DEVELOPMENT ASSESSMENT REPORT	
Application No.	REV/2020/0030
Address	14 Forrest Street HABERFIELD NSW 2045
Proposal	S8.2 Review of DA/2020/0346 for alterations and additions to the existing dwelling. Review involves amended plans.
Date of Lodgement	2 December 2020
Applicant	Mr Domenico Alvaro
Owner	Mr Domenico Alvaro Mrs Susan A Alvaro
Number of Submissions	Initial: 0
Value of works	\$488,675
Reason for determination at Planning Panel	Section 8.2 application previously refused by the Panel
Main Issues	<ul style="list-style-type: none"> Built form Colours and materials
Recommendation	Approved with Conditions
Attachment A	Recommended conditions of consent
Attachment B	Plans of proposed development

This report is an assessment of the application submitted to Council pursuant to Section 8.2 of the *Environmental Planning and Assessment Act 1979* for a review of Determination No. DA/2020/0346 for alterations and additions to the existing dwelling at 14 Forrest Street Haberfield.

Figure 1: Roof plan of proposed development demonstrating extent of rear addition (shown in grey).

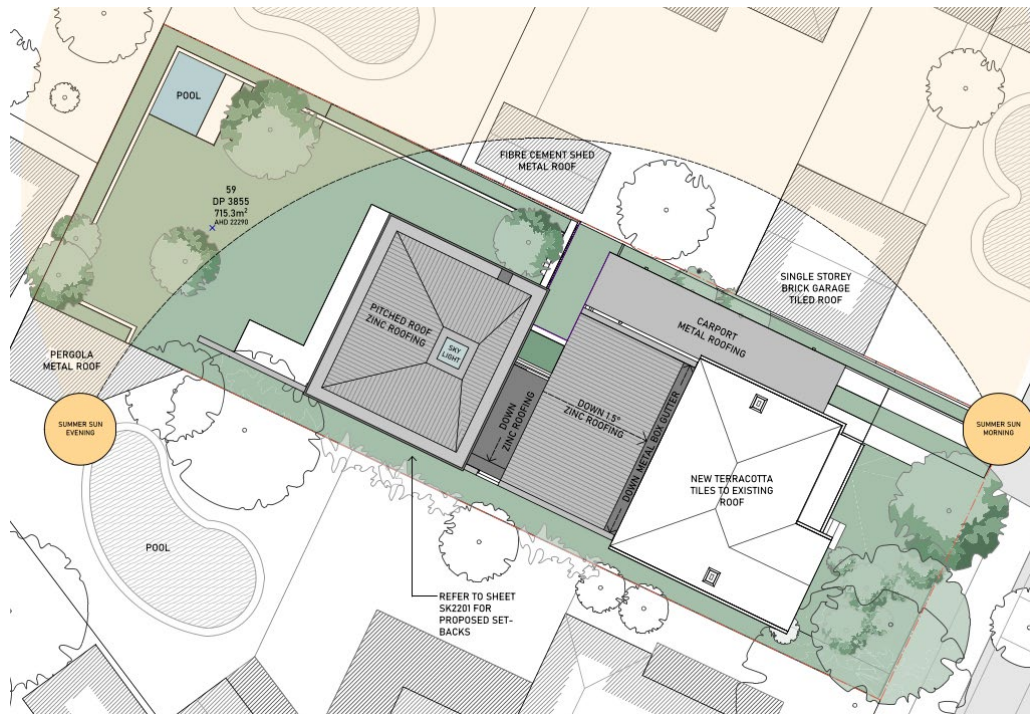
As demonstrated in Figure 1 below, the proposed addition at the rear extends greater in length than the original house. Despite the numerical non-compliance with control 2.6(g), the proposal is considered to generally achieve the intent of the building form provisions for the following reasons:

- The proposal results in an overall site coverage that is consistent with other development. As shown in Figure 2, the massing of the additions at the rear of the original building with no ancillary structures proposed at the rear allows a large rear garden area to be maintained that is consistent with, and in some cases greater than, the prevailing size of rear gardens in the area.

- The proposed side setbacks and massing of the rear addition means the rear extension is unlikely to be visible within the streetscape. Furthermore, the application proposes an appropriate pavilion-style extension with a link that creates a clear distinction between the original house and the rear addition.

Given the above, the proposed development is considered to achieve the intent of control 2.6(g) and is therefore considered acceptable.

Figure 3: Northern side elevation of proposed development demonstrating profile and shape of roof over rear pavilion extension (shown in grey).

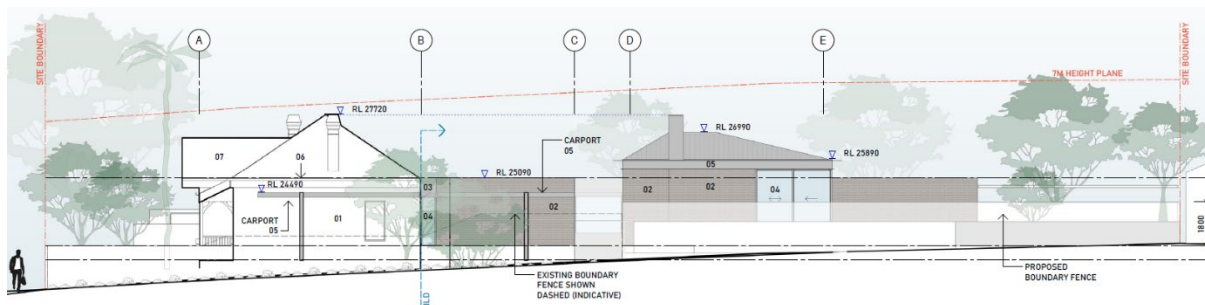
The DCP contains controls regarding the form, shape, and materials of roofs in Haberfield. As demonstrated in Figures 1 and 3, the application proposes two main roof forms over the rear additions, comprising a skillion roof with a 1.5° pitch over the addition directly off the rear of

the original dwelling, and a contemporary hipped form with a skylight at the apex over the rear pavilion extension.

The overall height, shape, and form of the proposed roofs are considered to be generally acceptable as the roofs are considerably lower in height than the principal ridge of the original roof and are of a form that is considered to relate sympathetically to the shape, pitch, and proportions of the original roof.

The application also proposes to replace the existing terracotta tiles on the main hipped roof form with slate roof tiles. Insufficient evidence has been provided with the application to determine the original roofing materials and therefore it has not been demonstrated that the proposed slate roof tiles are suitable for the HCA, nor has the material for the proposed ridge capping been provided. As such, it is recommended that a condition be included in the development consent requiring the existing terracotta tiles be retained and repaired, and where they cannot be repaired, they are to be replaced with unglazed terracotta Marseilles tiles to remain consistent with the HCA.

Figure 4: Comparison of original proposal (extent of rear addition shown outlined in yellow) and amended proposal (extent of rear addition shown outlined in red).

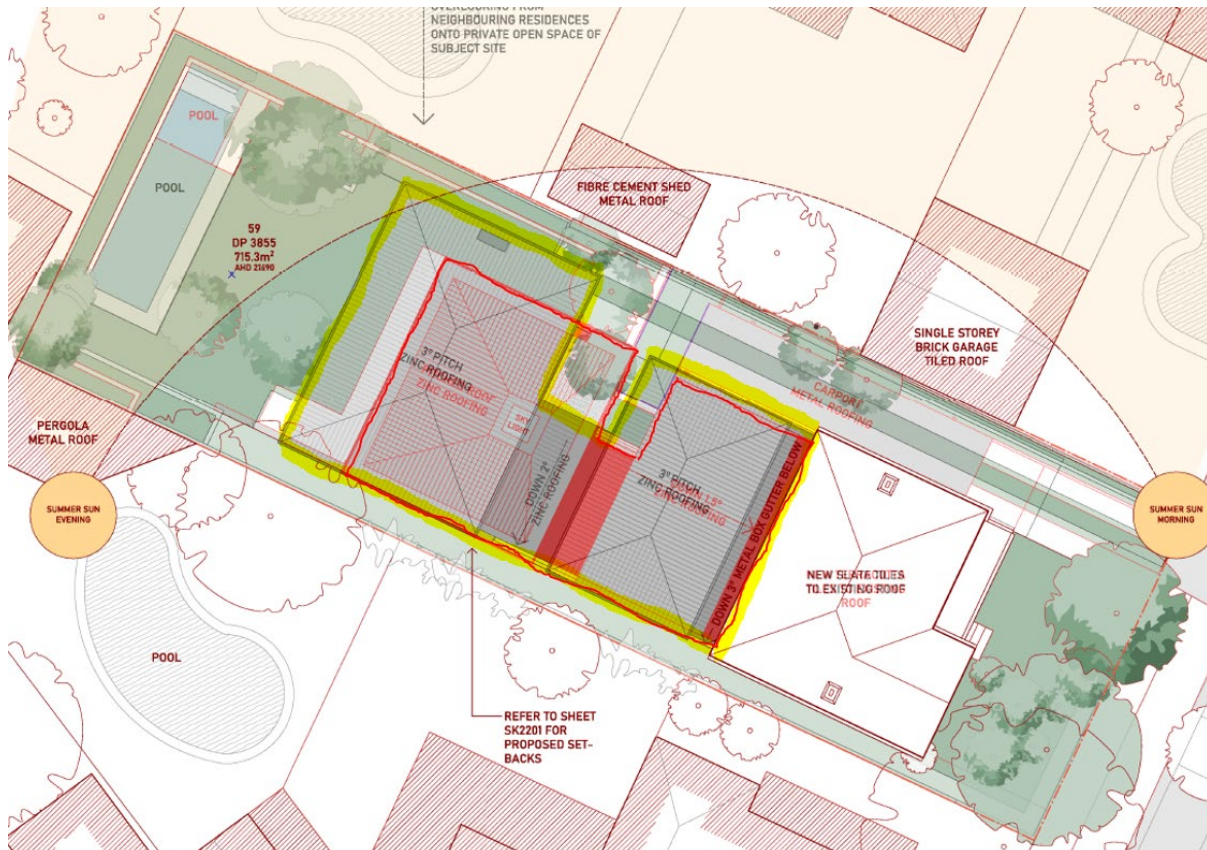
6. *The proposal is contrary to clause 2.6(g) of Chapter E2 – Haberfield Heritage Conservation Area of the Comprehensive Inner West Development Control Plan 2016 the proposal does not result in an extension less than and secondary to the original house.*

As demonstrated in Figure 4 below, the current design has considerably reduced the length of the rear addition from the original proposal. The amended design has deleted the lateral extension, reduced the overall size of the extension, and now appropriately masses the proposed addition behind the original building with appropriate side and rear setbacks.

Although the current design still results in a numerical non-compliance with control 2.6(g) of Chapter E2 of the DCP, as discussed in Section 5(c)(i) above, the proposal is considered to satisfy the intent of this control and the other relevant building form controls. The rear addition has been appropriately designed to remain subordinate to the original building and is of a form and scale that is consistent with the prevailing pattern of development in Haberfield. The development also results in an appropriate rear setback and site coverage that maintains a large rear garden area, which contributes positively to the significance of the HCA.

Given the above, the amended proposal is considered to have satisfactorily addressed this reason for refusal and the application is considered acceptable in this regard.
